**REMARKS**

These remarks are in response to the Office Action dated December 10, 2007. Claims 1, 4-6, 8-19, 21-26, and 29 are pending in this application. Claims 31-33 are added. No new matter is presented in the claim amendments and new claims presented herewith.

Application Serial No. 10/537,382  
Client/Matter No. 12867-3  
Reply to Office Action dated December 10, 2007

FIG 6

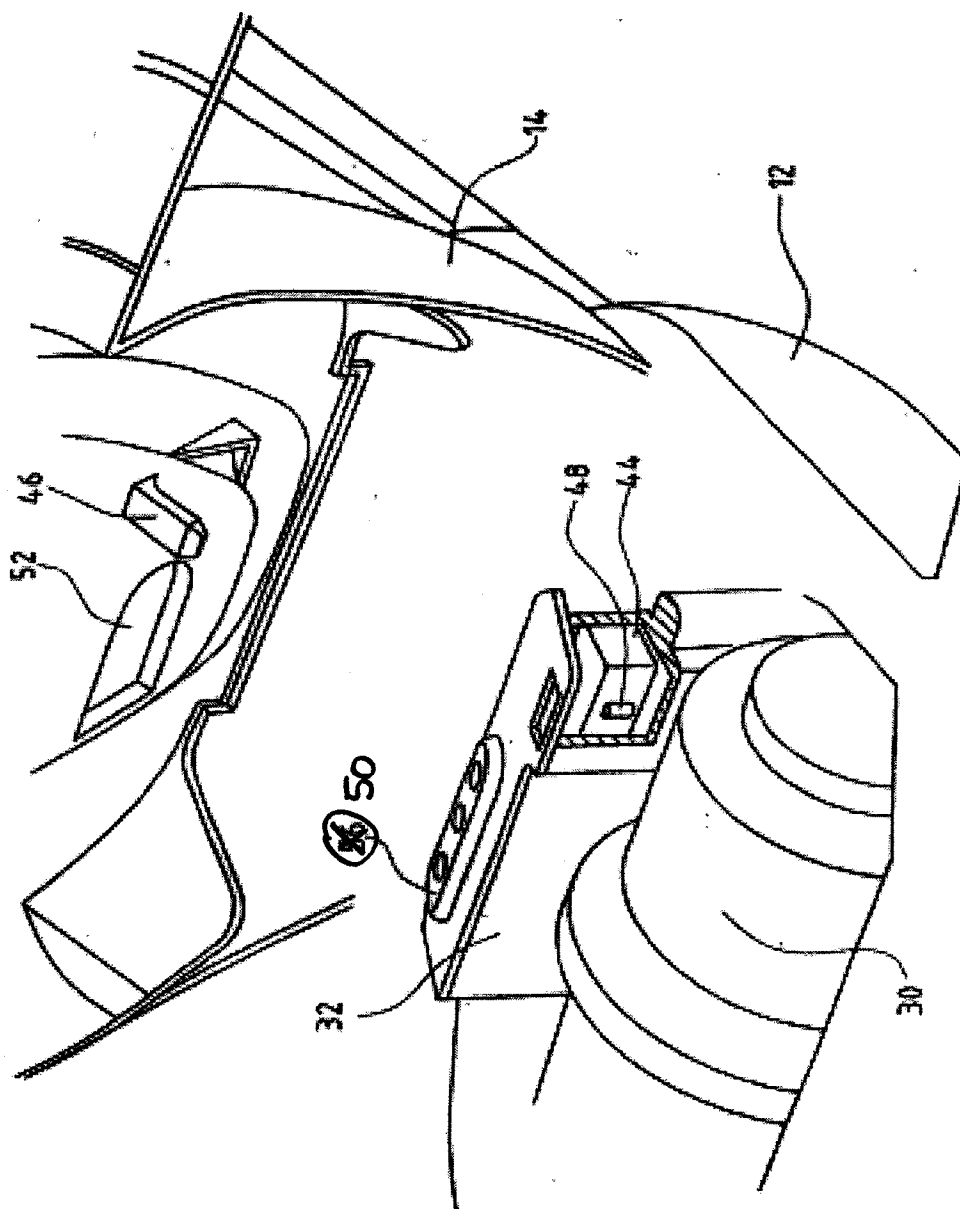
The drawings are objected to because the reference number "56" has been used to designate both an airflow passage and indicator lights. A Replacement Sheet is attached for amended Fig. 6, where reference number "56" has been replaced with reference number "50." Support exists for this amendment based upon Fig. 4 and the specification.

Change "56" to "50"
